APPEAL SUMMARY

Appeal ID: 23507	Project Address: 151 N Killingsworth St
Hearing Date: 2/26/20	Appellant Name: Justin Cammack
Case No.: B-014	Appellant Phone: 503-297-8791
Appeal Type: Building	Plans Examiner/Inspector: John Cooley, Corey Stanley
Project Type: commercial	Stories: 4 Occupancy: M, R-2, S-1 Construction Type: V-A, V-A, V-A
Building/Business Name: Koz Killingsworth LLC	Fire Sprinklers: Yes - Throughout
Appeal Involves: Erection of a new structure	LUR or Permit Application No.: 19-109551-CO
Plan Submitted Option: pdf [File 1] [File 2] [File 3] [File 4] [File 5]	Proposed use: Ground floor retail & living units, 3 upper floors living units

LIFE SAFETY CHECKSHEET

Street Address:	151 N KILLINGSWORTH ST					
Description of Work:	DEFERRED SUBMITTAL FOR FIREPROOFING					
The following assumptions were made when reviewing your project:						
Code Edition	Occupancy group	Construction Type	Building Area	Stories	Sprinklers	Alarms
2014 OSSC	M / R-2 / S-1	V-A V-A V-A	SF	4	Yes

2ND FLOOR
FRAMING PLAN

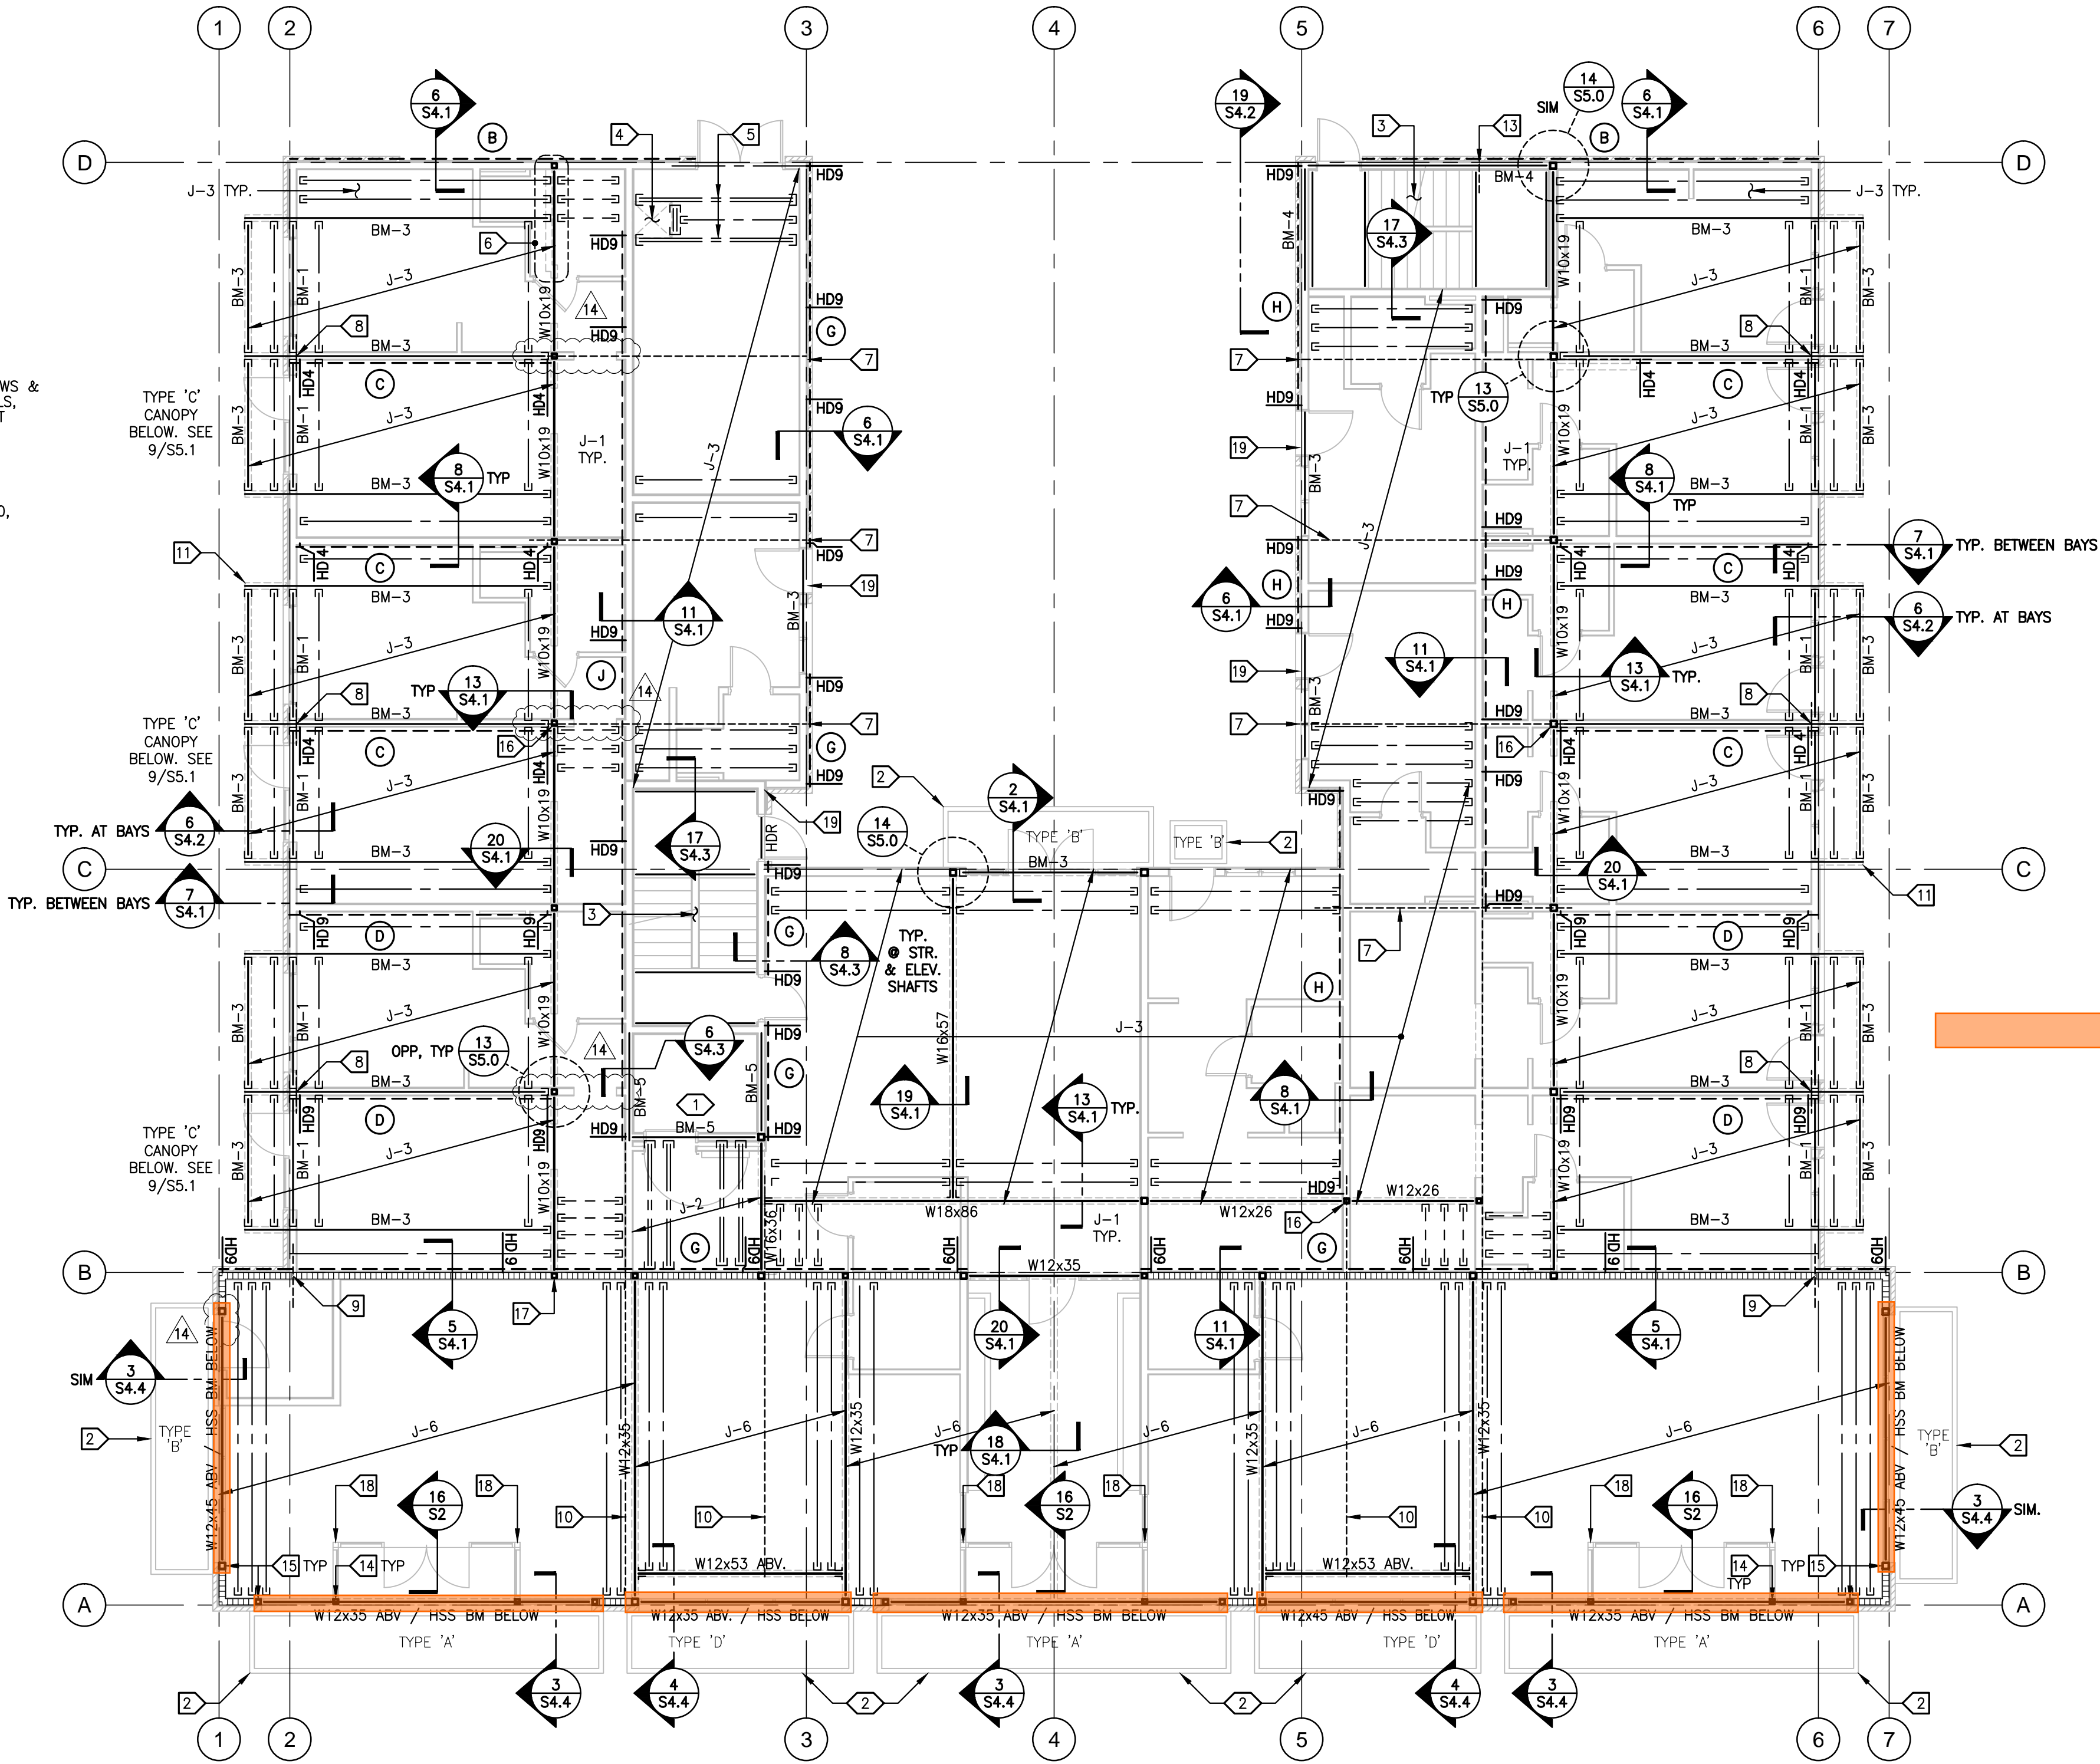
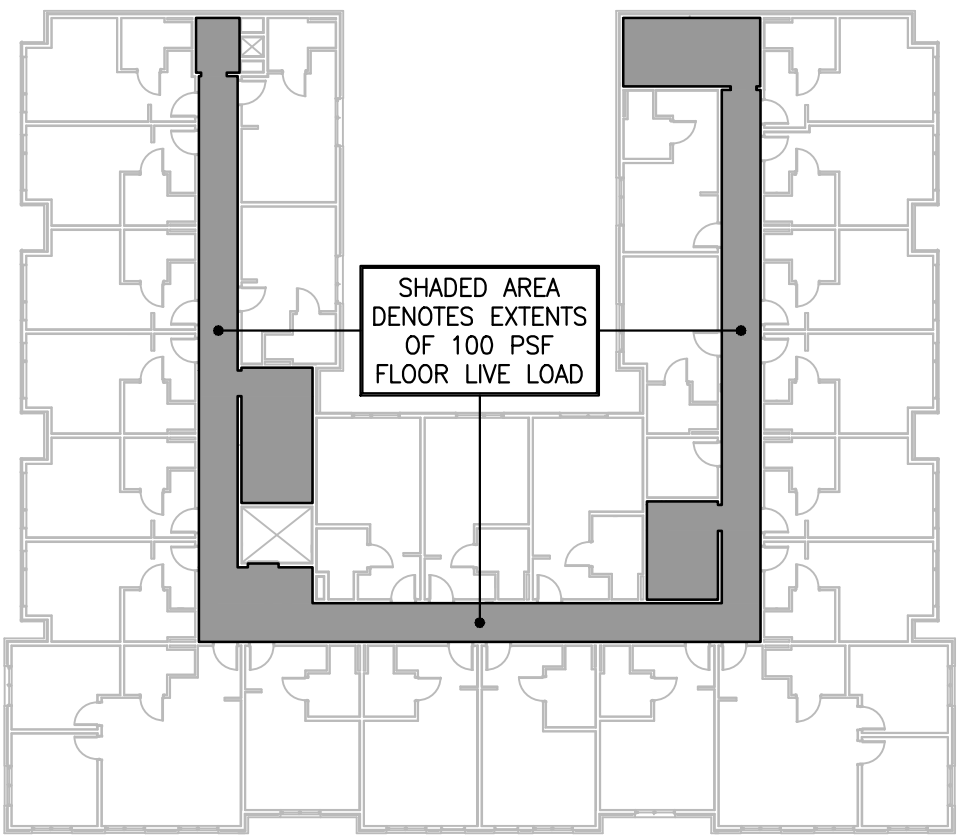
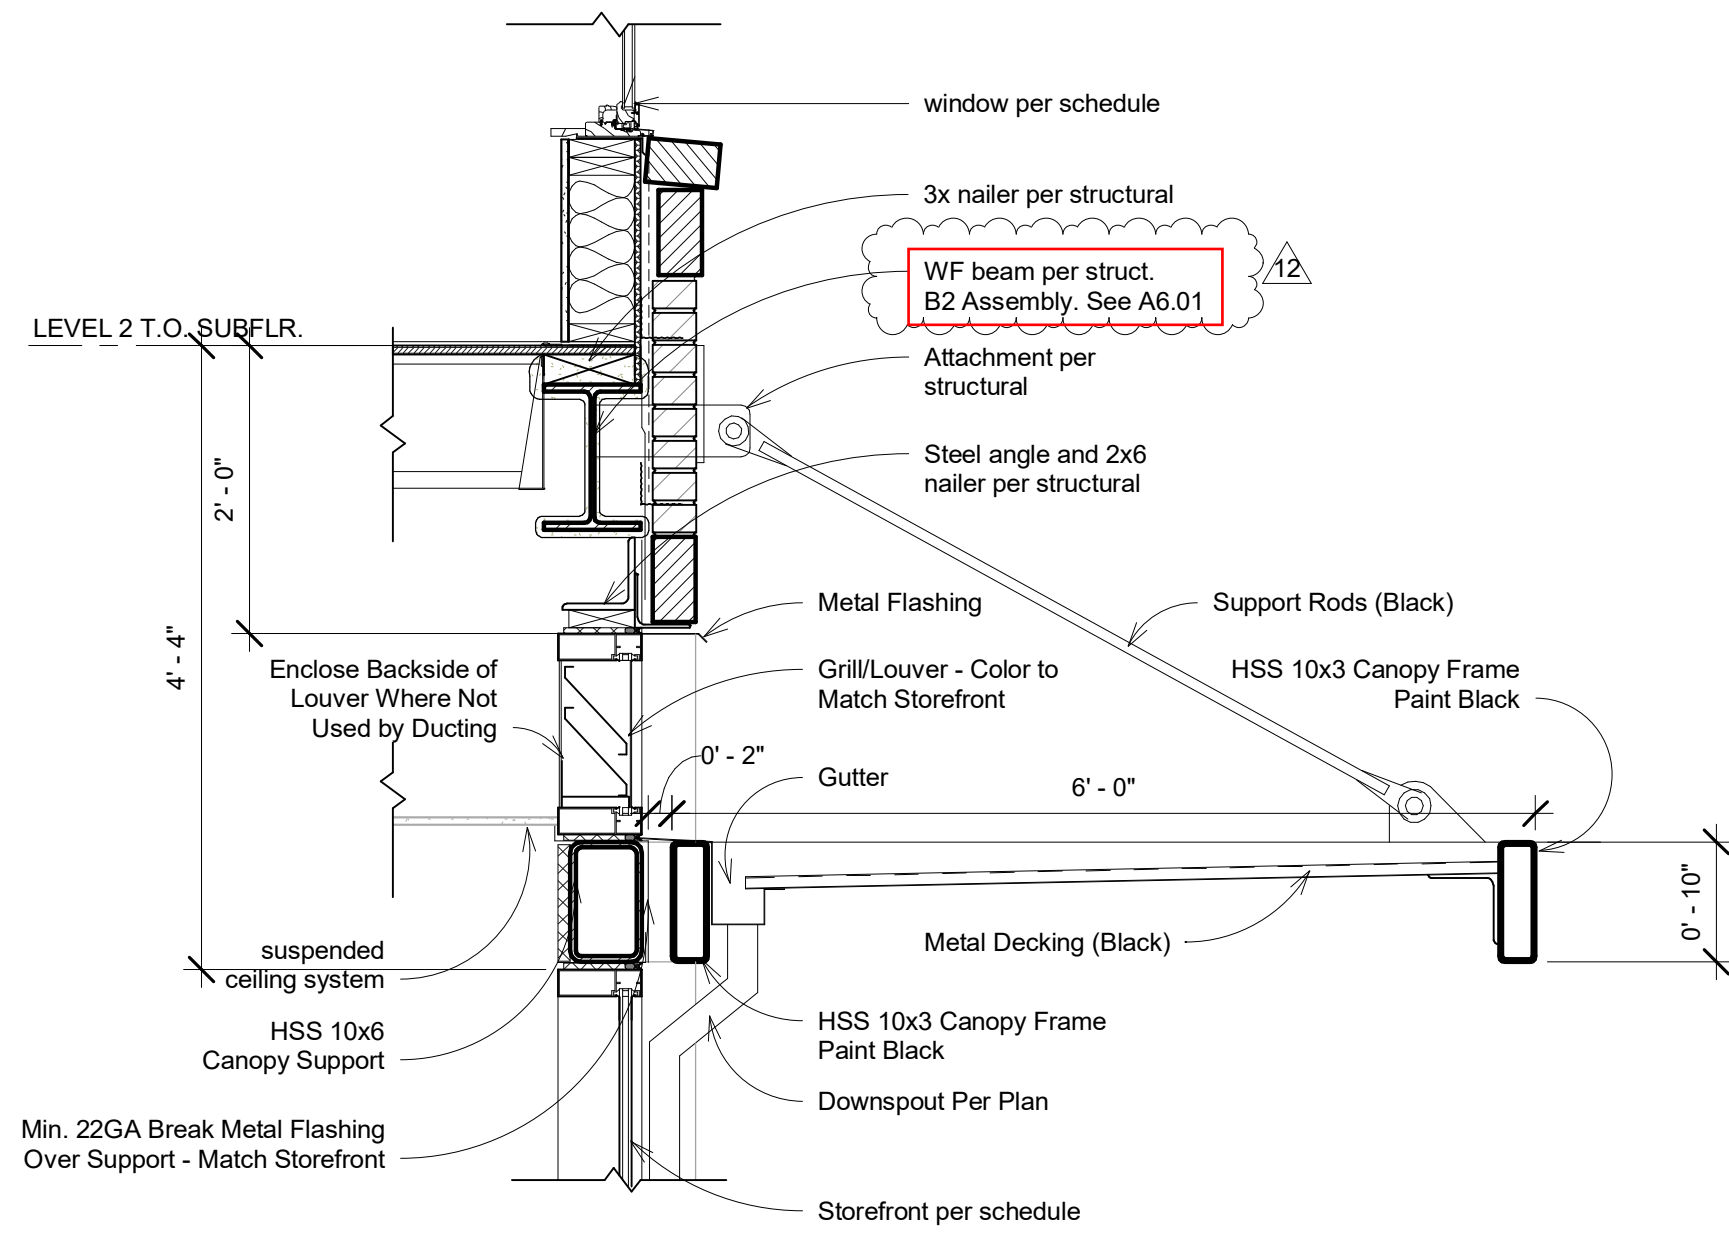
- Locations of SFRM @ W 12x35/45 Beams
